City of Portland, Maine – Building or Use Permit Application 389 Congress Street, 04101, Tel: (207) 874-8703, FAX: 874-8716

BUILDING PERMIT REPORT

DATE: 24/April/99 ADDRESS: 9 Sandpiper Rd. P.I. CBL: 085-M-007
 REASON FOR PERMIT: To Amend Permit # 990144
 BUILDING OWNER: Barkhoff Malmquist
 PERMIT APPLICANT: _____ /Contractor owner
 USE GROUP R-3 BOCA 1996 CONSTRUCTION TYPE 5 B

BUILDING PERMIT REPORT

Site Plan for
 Darkhuff Malmquist
 #7 Sandpiper Road
 Peaks Island Maine
 Lot 7 Block M Map 85
 Revised 4/21/99

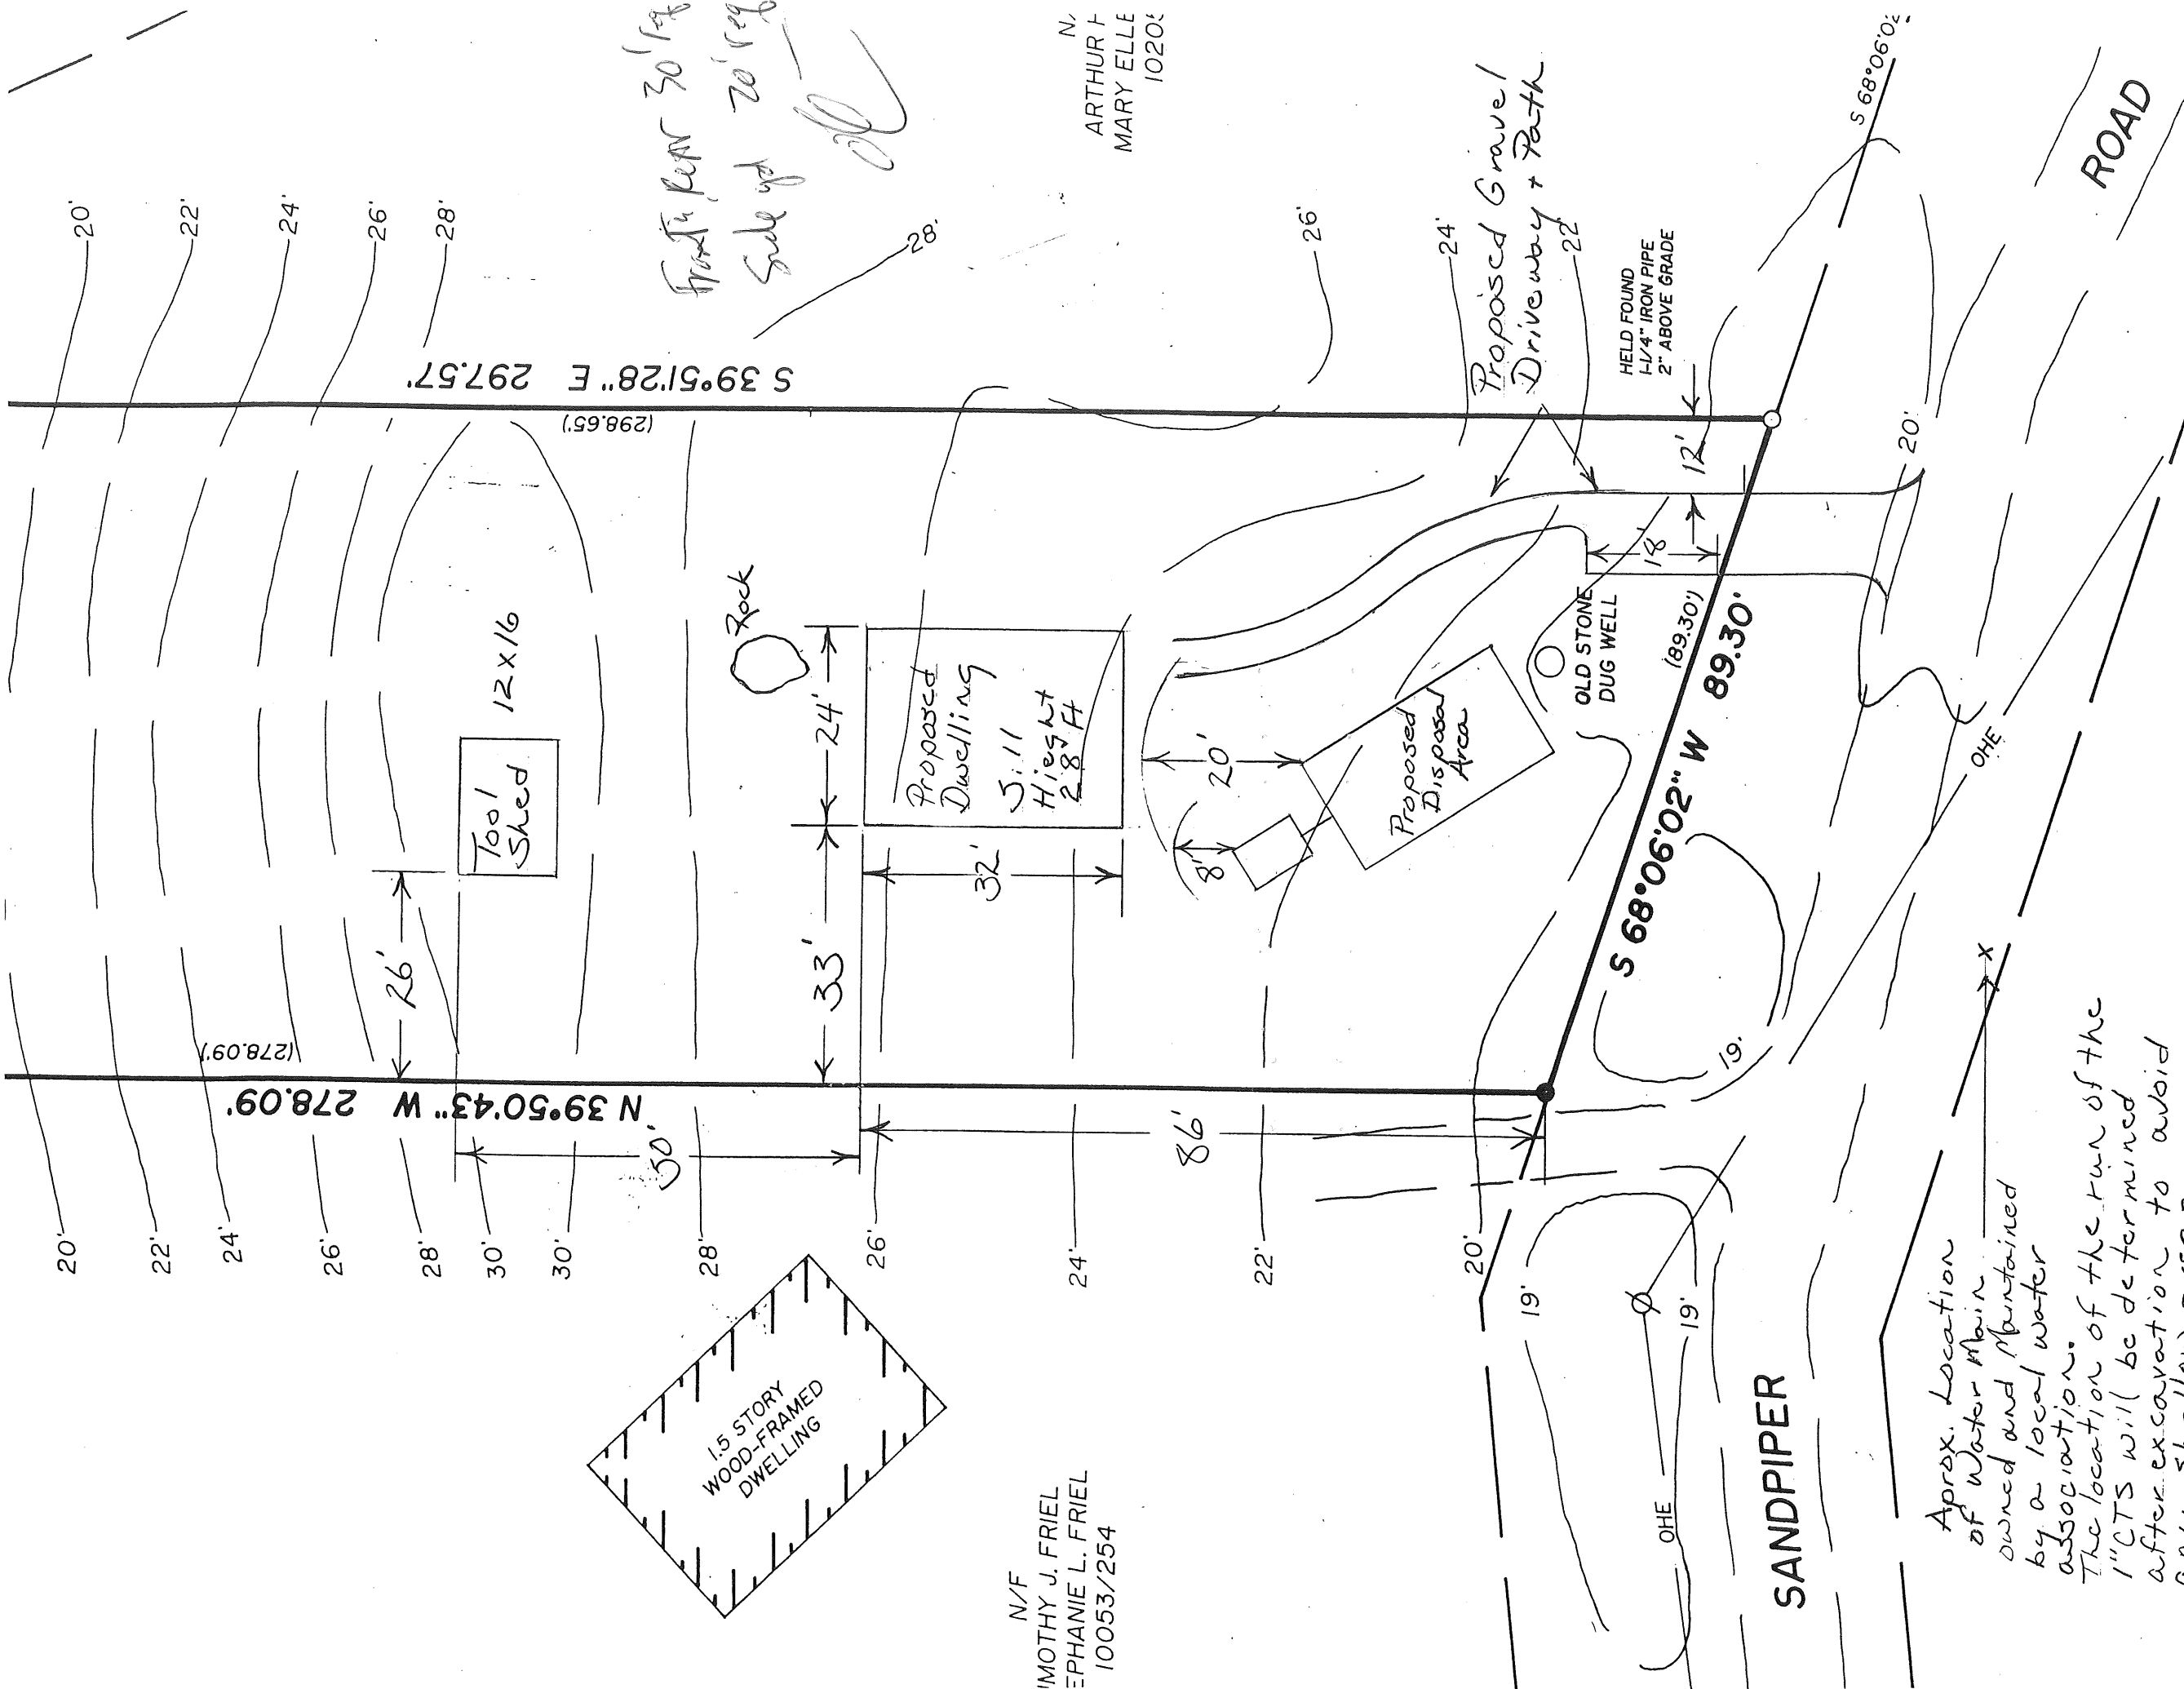
Items that are Revised; House Moved by 6', Driveway Moved by 7'
